Access Compliance Report

Public Rights-of-Way

(Curb Ramps)

Intersection ID: 29420	Main Street: BRADSTREET_COMMONS_WY	Cross Street: SALINGER_WY	Location: NW
ADA ID: E2F905079775	Ramp Type: BlendTrans1	Initial Pass/Fail: Fail	Overall Compliance: No
Severity Score: 8.75			
Codes/Mitigation Info/Possible Solution		Field Measurements/Component Compliance

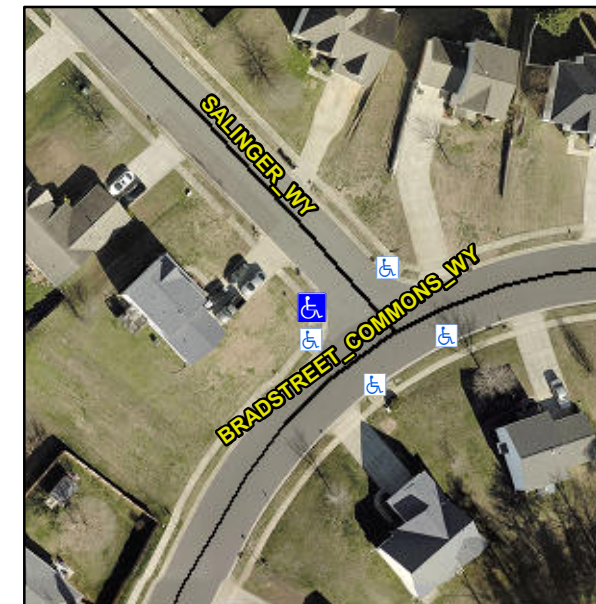
Not Found, R304.5.1

Compliance	Description	Data	Compliance	Description	Data
N/A	Ramp Length (in)	47.5	Yes	BlendTrans Slope (%)	3.7
No	Ramp Width (in)	46.0	Yes	BlendTrans XSlope (%)	1.9
N/A	Flare Type LT	N/A	N/A	Flare Type RT	N/A
N/A	Flare Slope LT (%)	N/A	N/A	Flare Slope RT (%)	N/A
N/A	Flare Traversable LT?	N/A	N/A	Flare Traversable RT?	N/A
N/A	Landing Length (in)	N/A	N/A	DWS Provided?	N/A
N/A	Landing Width (in)	N/A	N/A	DWS Contrast?	N/A
N/A	Landing Slope (%)	N/A	N/A	DWS Length (in)	N/A
N/A	Landing X Slope (%)	N/A	N/A	DWS Full Width?	N/A
N/A	Landing Curb? (Y/N)	N/A	N/A	DWS Offset (in)	N/A
N/A	Shared Landing?	N/A			
N/A	Gutter Ponding?	N/A	N/A	Gutter Slope (%)	N/A
N/A	Gutter Lip Ht (in)	N/A	N/A	Gutter X Slope (%)	N/A
N/A	Painted X Walk1?	No	N/A	Painted X Walk2?	N/A
	X Walk 1 Direction	To NE		X Walk 2 Direction	N/A
	X Walk 1 Width (in)	N/A		X Walk 2 Width (in)	N/A
	X Walk 1 Slope (%)	6.7		X Walk 2 Slope (%)	N/A
	X Walk 1 X Slope (%)	3.1		X Walk 2 X Slope (%)	N/A

N/A	Ramp inside XWalk1?	N/A	N/A	Ramp inside XWalk2?	N/A
	Road Slope (%)	3.1		Clear Space?	N/A
	Road X Slope (%)	6.7	N/A	Clear Space to XWalk (in)	N/A
N/A	Any Obstructions?	N/A	N/A	Storm Grate/Utility Hazard?	N/A
	Obstruction Type			Storm Grate/Utility Type	
		N/A			N/A
			Yes	Surface Condition? (G/P)	Good
			No	Curb Slope (%)	17.9

Remove & Replace Curb Ramp With Two New Directional Ramps or Equivalent.
